DWN	C.C.	12/93	ROCKFORD FOSGATE CORPORATION DIVISION TEMPE AZ
CHK			
ENGR	C.C.	12/93	TITLE SCHEMATIC PUNCH 60ix OUTPUT
APVD			
APVD			SIZE B SCALE NONE SHEET 1 OF 2
MATL/FS			FILE NAME SCH06941 PART NO. SCH-0694 REV M

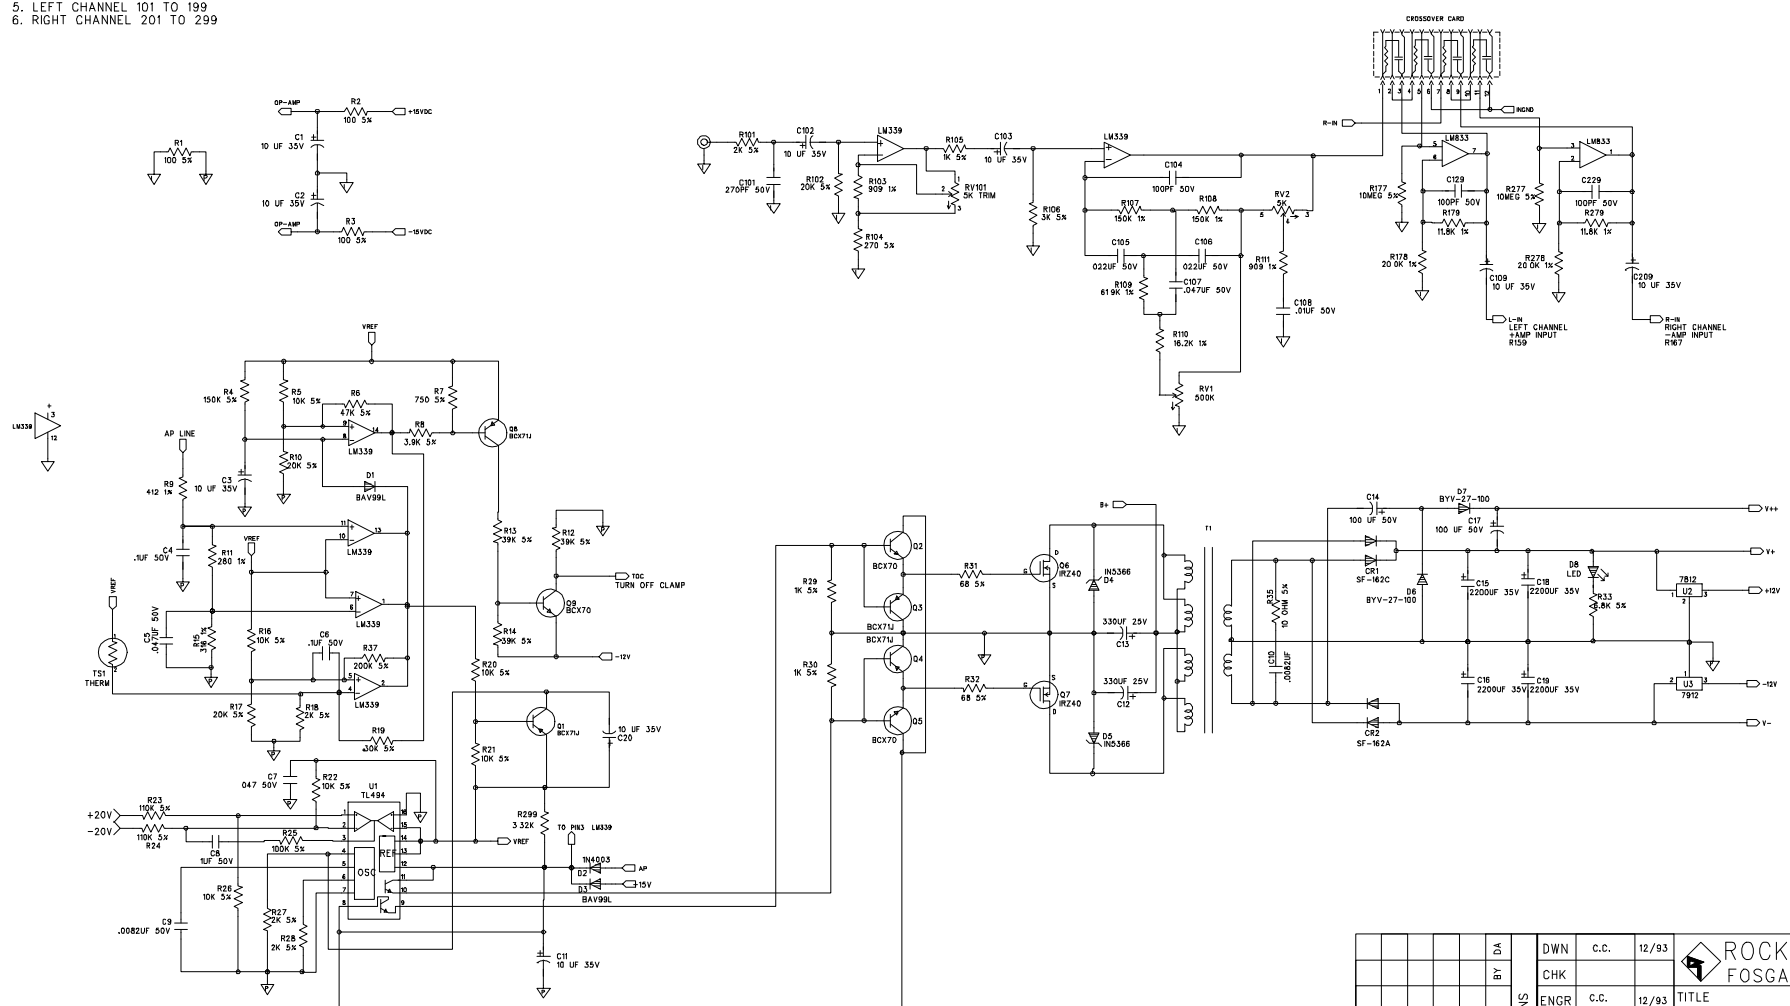
330UF 25V CAP (CERHF-337A-024) HAS BEEN REPLACED. REF DES C12 13
NEW PART # 330UF 63V (CERHF-337D-024)
PER ECO 3633

SS-209SM (BCX70J) HAS BEEN REPLACED
REF DES Q2 5 9 101 102 103
104 112 114 120 131
NEW PART # SS-0792 (MMBT3904LT1)
SS-210SM (BCX71J) HAS BEEN REPLACED
REF DES. Q1 3 4 8 105 106 107 108
109 115 119 126 129 130
NEW PART # SS-0791 (MMT3906LT1)
PER ECO 3571

PART # RM/10-303B (30K 5%) HAS BEEN REPLACED. REF DES R194 R294
NEW PART # RM/10-2002B (20K 1%)
NEW REF DES R156 R256
PER ECO 3519

NEW PART HAS BEEN ADDED TO SCHEMATIC
CER-1065M (10UF 35V)
REF DES C35 C36
PER ECO 3521

PART # RM/10-102B (1.0K 5%) HAS BEEN REPLACED. REF DES R145 245
NEW PART # RM/10-751B (750 OHM 5%)
PER ECO 3508

PART # RM/10-103B 10K 5% HAS BEEN REPLACED. REF DES R129 R229
NEW PART # RM/10-683B 68K 5%
PER ECO 3513

PRIMARY PART # SS-802SM TL494
SUBSTITUTE PART # SS-0722 TL594
PER ECO 3450

PART # RM/10-154B 150K OHM HAS BEEN REPLACED
REF DES R23 AND R24
NEW PART # RM/10-114B 110K OHM
PER ECO 3498
